UNITED STATES PATENT AND TRADEMARK OFFICE

APPLICATION NO.	FILING DATE	FIRST NAMED INVENTOR	ATTORNEY DOCKET NO.	CONFIRMATION NO.
09/873,522	06/04/2001	Richard E. Scordato	M1005/7006 RJK	3542
26453	7590	01/06/2005	EXAMINER	
BAKER & MCKENZIE			GORDON, BRIAN R	
805 THIRD AVENUE			ART UNIT	
NEW YORK, NY 10022			PAPER NUMBER

Office Action Summary	Application No. 09/873,522	Applicant(s) SCORDATO ET AL.	
	Examiner Brian R. Gordon	Art Unit 1743

DETAILED ACTION

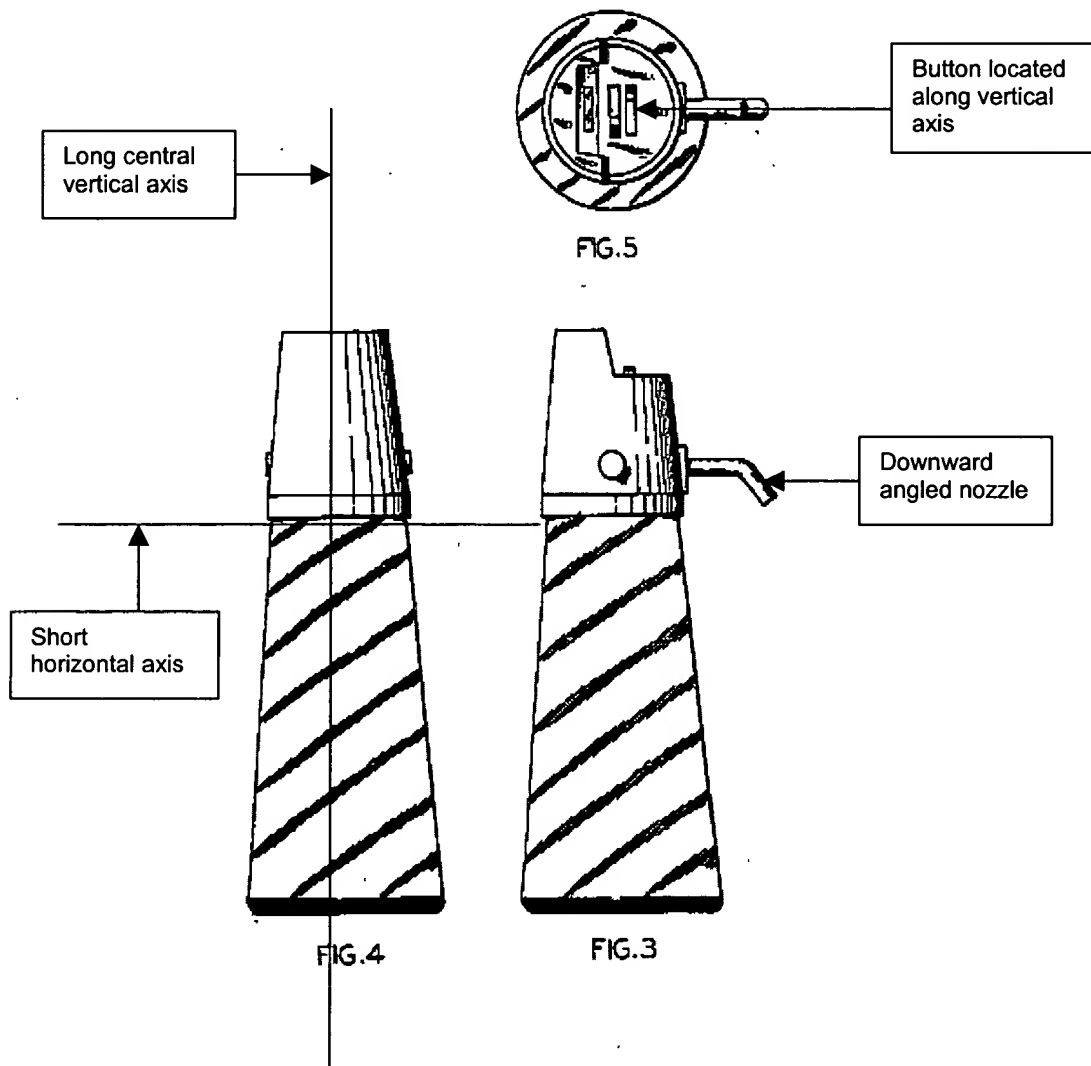
Chi discloses a dispenser that appears to be designed with an actuator button aligned with the central vertical axis of the dispenser. The dispenser also comprises a nozzle that extends from a point on the body of the dispenser and the nozzle appears to be at angle between 60 and 80 degrees relative to the axis. The device also comprises a stable base.

As to the “nozzle portion extending from a point on said body portion at a downward angle”, such language is not interpreted as being limited to a nozzle which is angled from a defined point on the body. In other words the language does not exclude a nozzle from extending from a point on the body and downward as that of Chi.
